SCIENTIFIC-ATLANTA INC 6A
TRANSDUCER CALIBRATION SYSTEMS. (U)
JUN 67

9
INTERIM DEVELOPMENT REPORT

6
TRANSDUCER CALIBRATION SYSTEMS

1. This report summarizes work accomplished under Naval Ship Systems Command Contract N00024-67-C-1211 for the period 11 January 1967 through 30 June, 1967.

ATTACHMENT 1

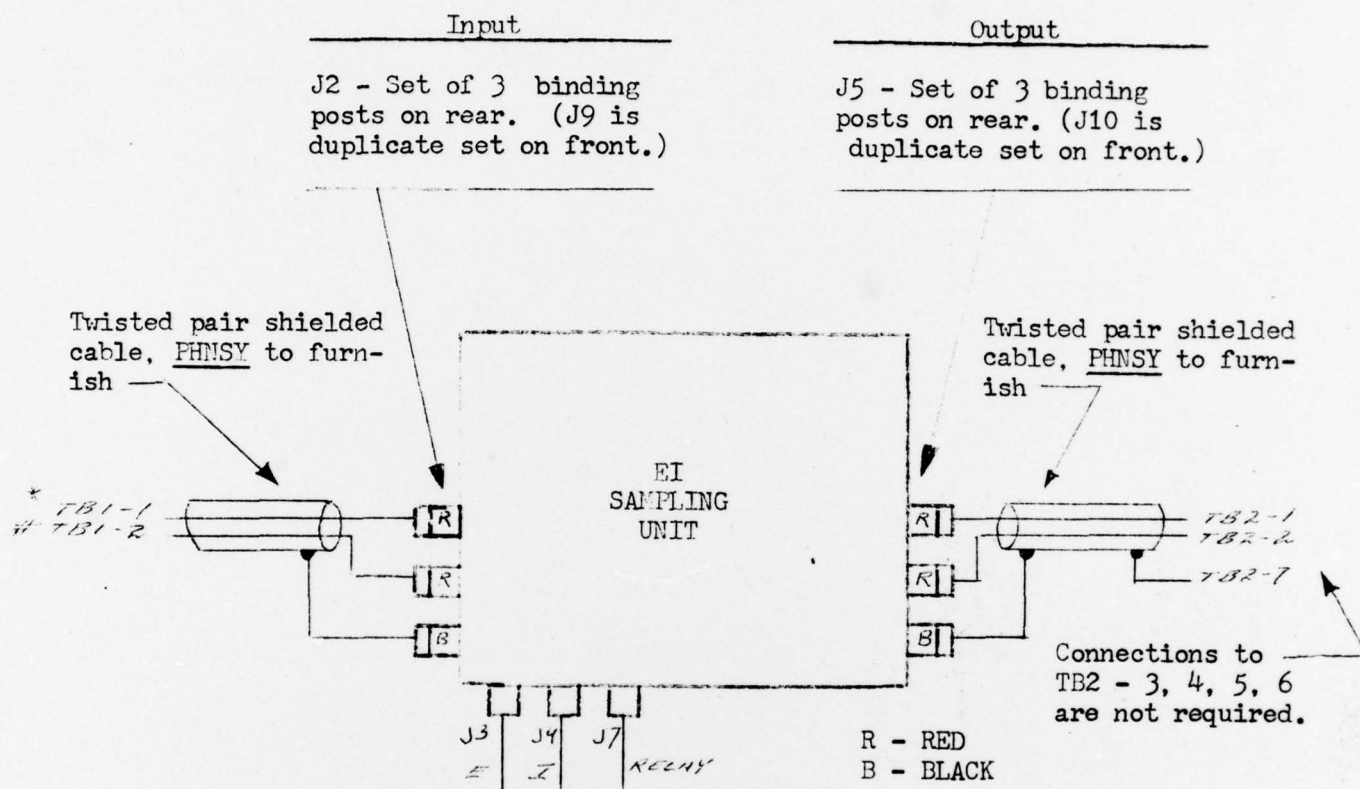
3. The following points concern equipment racks 1 and 2 that you are providing:
 - a. The input connections to the power amplifier are shown on sheet four of the set of sketches. I recommend that the ground at TB-8, terminal 1 be removed. PHNSY should make the cable to connect the input of the power amplifier to the SA console. It is recommended that you use RG 59A/U coaxial cable. Terminate the console end of the cable with a standard BNC-series connector. Terminate the power amplifier end of the cable at TB-8, terminals 1 and 2. SA will furnish a precision 75-ohm shunt that should also be connected across these two terminals. In order to get the length of the cable correct, assume that the mating connector for

- b. The input and output connections to the sampling unit are shown on page two of the set of sketches. The details are not quite correct. Attachment 1 to this letter gives the interface requirements. Note from this attachment that PHNSY is to furnish two cables, and furnish information so that SA can make three cables.
- c. The tentative layout of the equipment in rack 1 and 2 is shown on sheet 1 of the set of sketches.
- (1) The EI sampling unit is $3\frac{1}{2}$ inches high.
- (2) The following additional equipment should also be mounted in these racks:

*,# If sample box and capacitor box are interchanged, (see paragraph 2b of cover letter) then,

SA will fabricate and send these three cables. They connect to the console interface panel. PHNSY is to furnish conservative estimate of length required. Interface panel is at the middle, bottom, rear of the console.

ATTACHMENT 4 - SHEET 1 OF 2

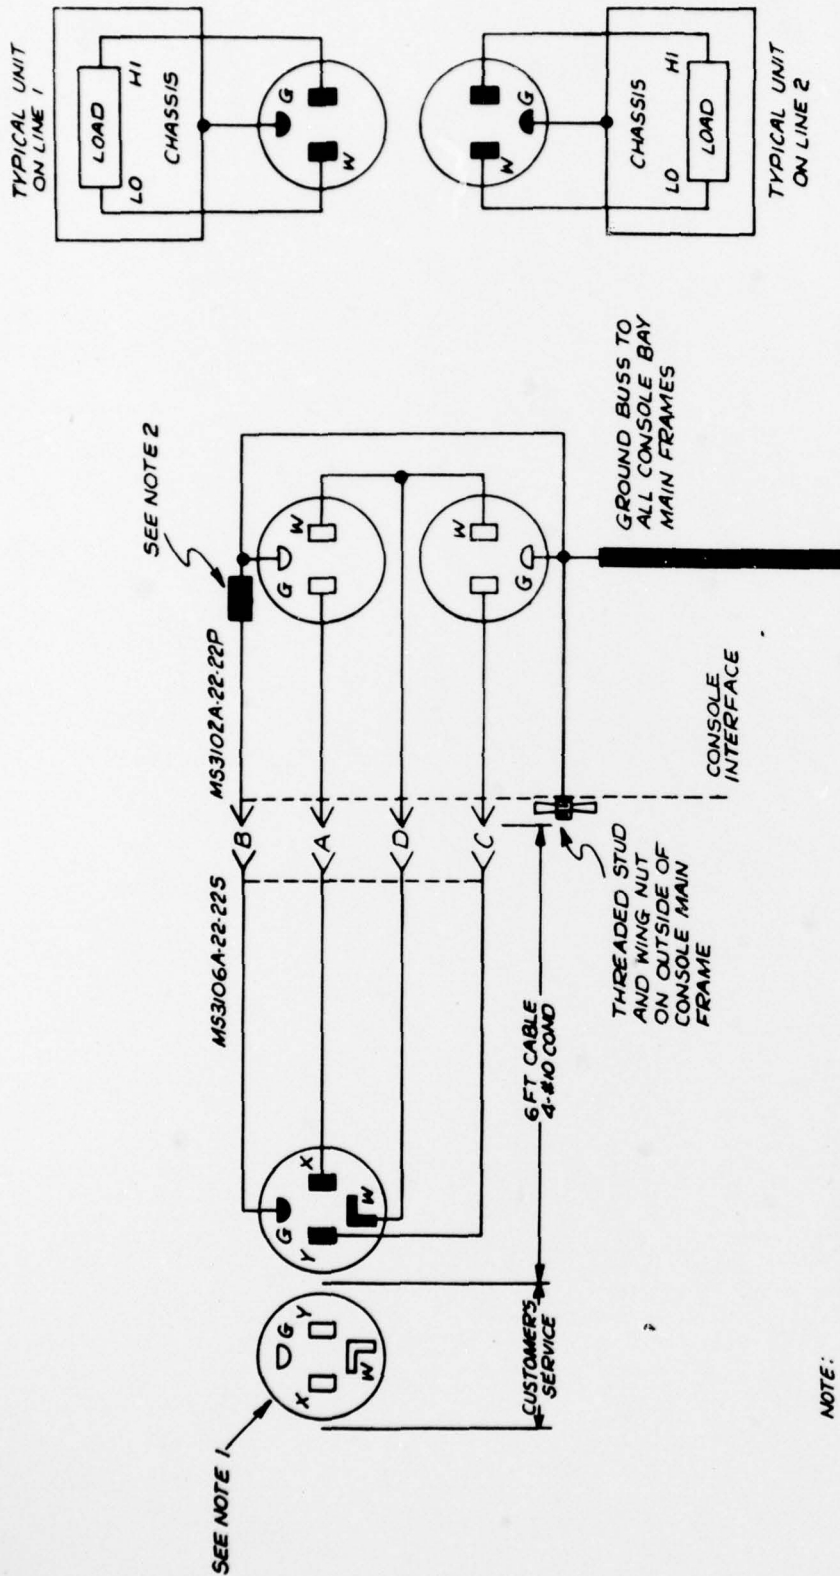
As indicated in enclosure 1, we are furnishing a 6-foot extension cable terminated with a NEMA type 14-30 P plug (Hubbel Type 9432, Arrow-Hart Type 5732, or equivalent). This will require installation of 115/230 volt, 3-pole, 4-wire service terminated with a NEMA type 14-30R receptacle (Hubbel Type 9430, Arrow-Hart Type 5743, or equivalent).

The console end of the extension cable will be terminated with a type MS 3106A-22-22S connector and its mating connector will be mounted on the console. The power line wiring internal to the console will be such that the instrumentation equipment will be divided approximately equally between the 115 V phase X to W and the 115 V phase Y to W.
